**SUSQUEHANNA STEAM ELECTRIC STATION
PROPOSED AMENDMENT NO. 228 TO LICENSE
NPF-14: REVISION TO THE LEGEND OF
TECHNICAL SPECIFICATION FIGURE 3.4.10.1
AND AMENDMENT NO. 191 TO LICENSE
NPF-22: REVISION TO THE LEGEND OF
TECHNICAL SPECIFICATION FIGURE 3.4.10.1
AND REVISE A REFERENCE IN TECHNICAL
SPECIFICATION SECTION 5.6.5.b
PLA-5148**

**Docket Nos. 50-387
and 50-388**

ATTACHMENT 1 TO PLA-5148

Figure 3.4.10-1 (page 1 of 1)

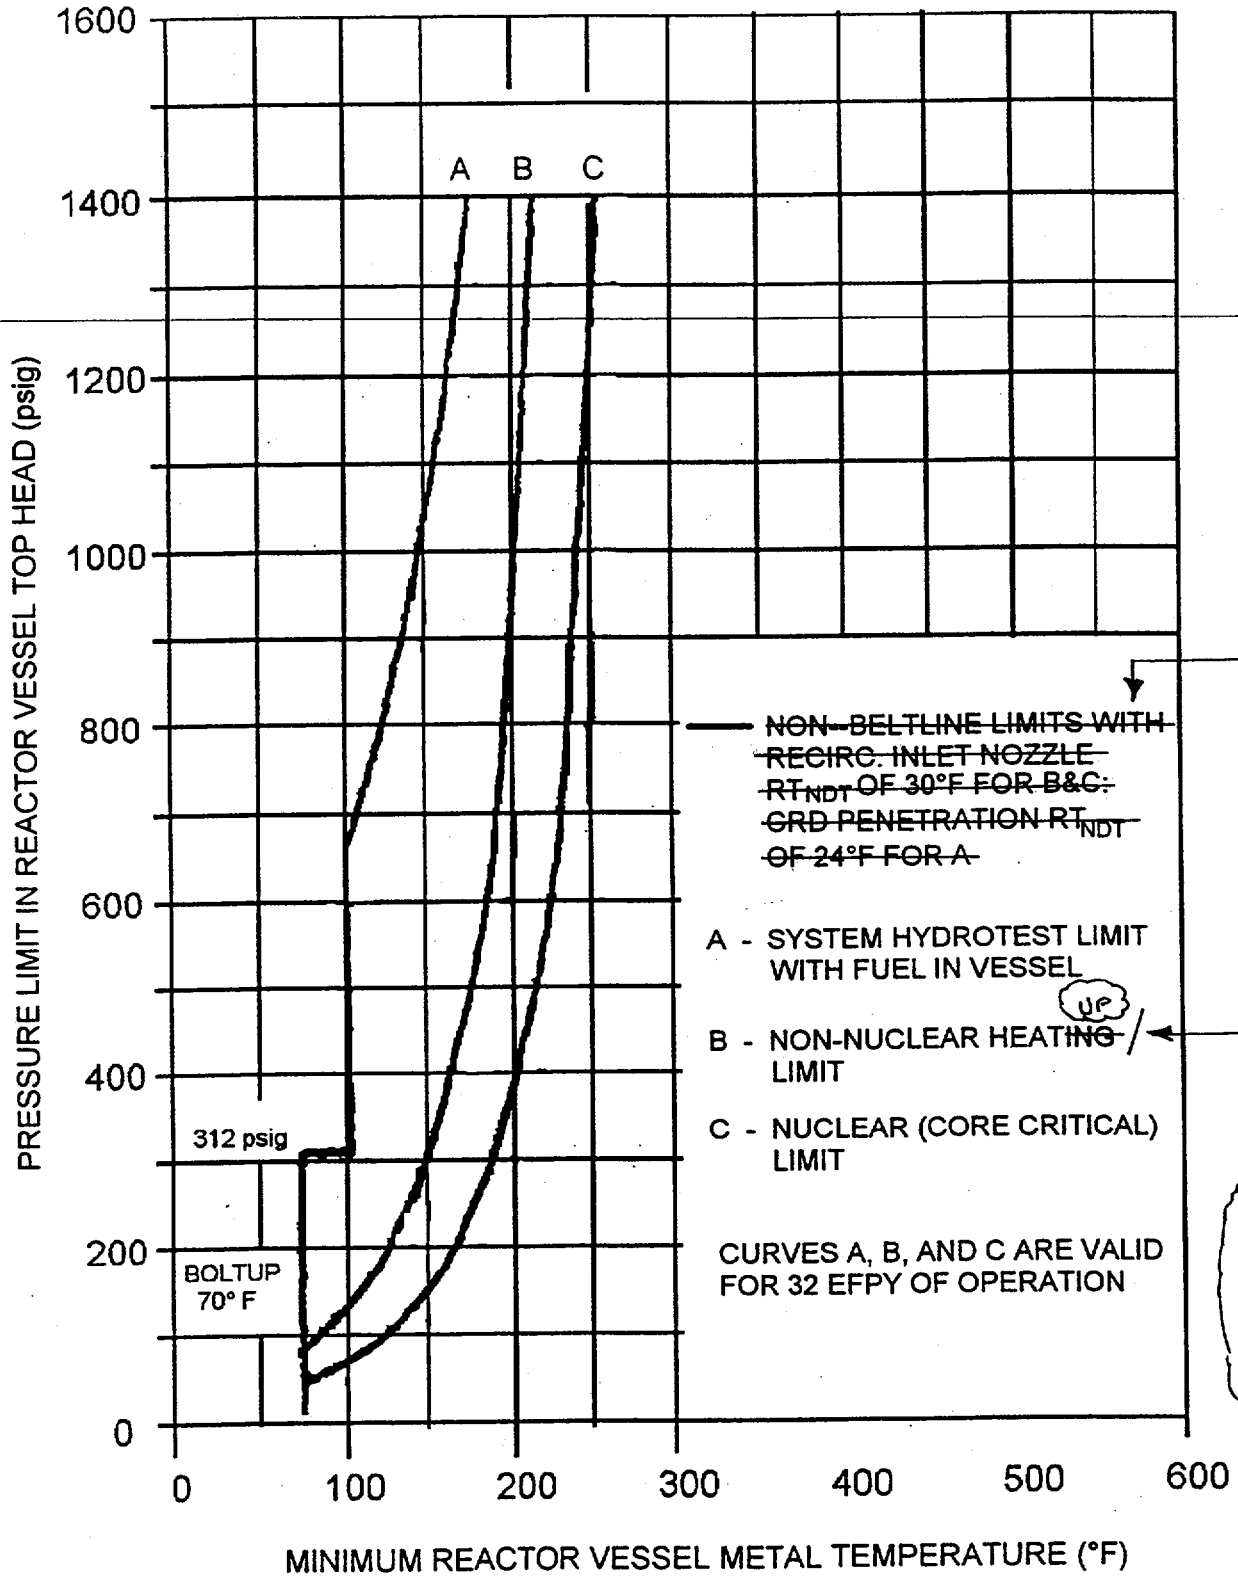
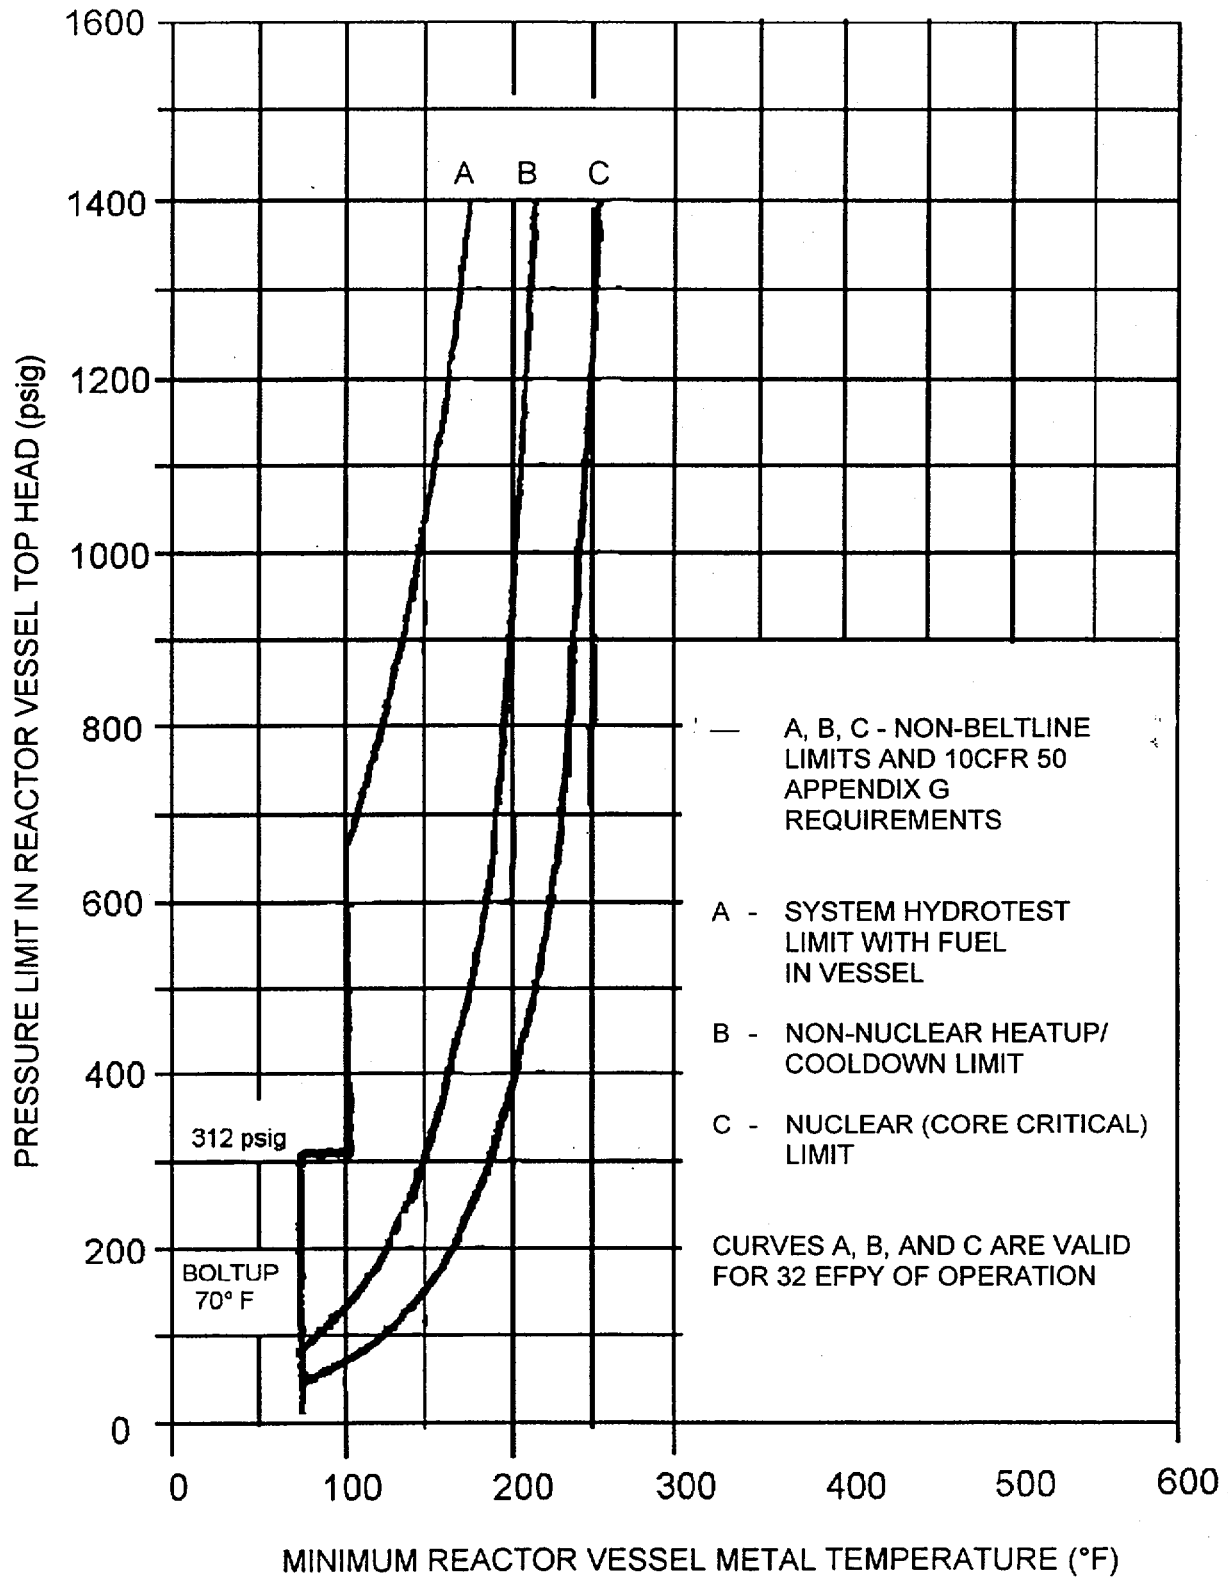
This proposed revision to Technical Specification Figure 3.4.10.1, "Reactor Vessel Pressure vs. Minimum Vessel Temperature" is administrative in nature, and is applicable to both Unit 1 and Unit 2. The proposed revision is intended to clarify the legend on Figure 3.4.10.1 to broadly state the intent of the curves. Identical Pressure/Temperature (P/T) curves appear in both the Technical Specifications (Figure 3.4.10.1) and in the FSAR (Section 5.3). During the current licensing basis review of the FSAR it was determined that, while the P/T curves are technically correct, the legend information on the Figures in the Technical Specifications and the FSAR could be misleading and require clarification.

In the past the legends on the Figures in the FSAR were revised in an attempt to very briefly describe the technical basis of the curves. The legends on the Technical Specifications Figures were not revised. Consequently, the descriptions on the Figures in the FSAR and the Technical Specifications are not consistent and results in the same Figure in the Technical Specifications and the FSAR having different descriptions of the limiting non-beltline P/T curves.

The SSES P/T limiting non-beltline curves are composite curves established by superimposing stress analysis limits for those portions of the reactor pressure vessel (RPV) onto the most restrictive portions of the RPV (feedwater nozzles for the upper vessel region and CRD penetrations for the bottom head region). Development of the curves has evolved and now includes consideration of the highest nil ductility temperature among all of the vessel nozzles and other non-beltline component materials. This value is then applied to the appropriate feedwater nozzle or CRD penetration limit. The discussion of this technical basis methodology is explained in FSAR section 5.3.1.5.

A, B, C - Non-Beltline Limits
and Increased Appendix G
Requirements

5.6.5 COLR (continued)

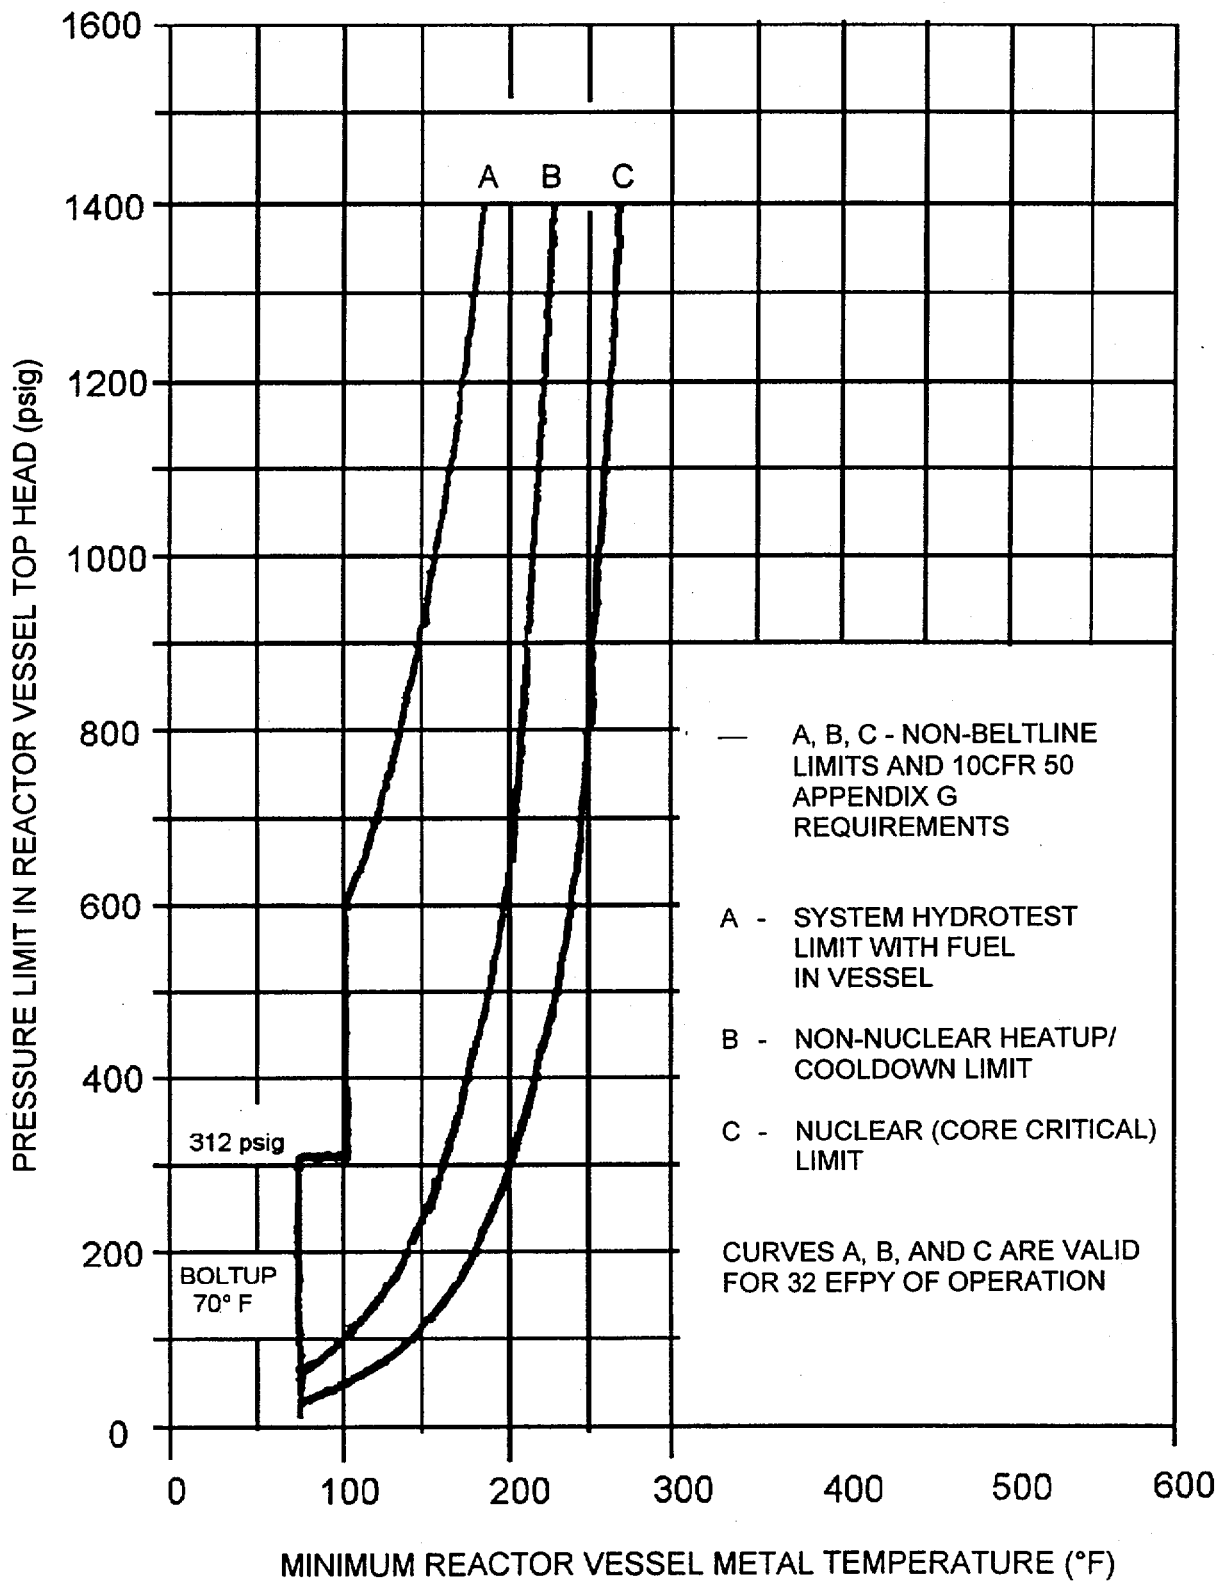
The proposed revisions to section 5.6.5.b of the Unit 2 Technical Specifications (reference 4 to the Core Operating Limits Report (COLR)) are editorial in nature. The revision corrects the supplement dates to the existing referenced document. The current Technical Specifications only include the issuance date of the original supplement.

and 2 (MARCH 1983), and Volume 1,
Supplement 3 (NOVEMBER 1990)

3. XN-NF-85-67(P)(A), Revision 1, "Generic Mechanical Design for Exxon Nuclear Jet Pump BWR Reload Fuel, "Exxon Nuclear Company, Inc., September 1986.
4. XN-NF-80-19(A), Volume 1, and Volume 1 Supplements 1 and 2 (March 1983), and Volume 1, Supplement 3 (November 1990), "Exxon Nuclear Methodology for Boiling Water Reactors: Neutronic Methods for Design and Analysis," Exxon Nuclear Company, Inc.
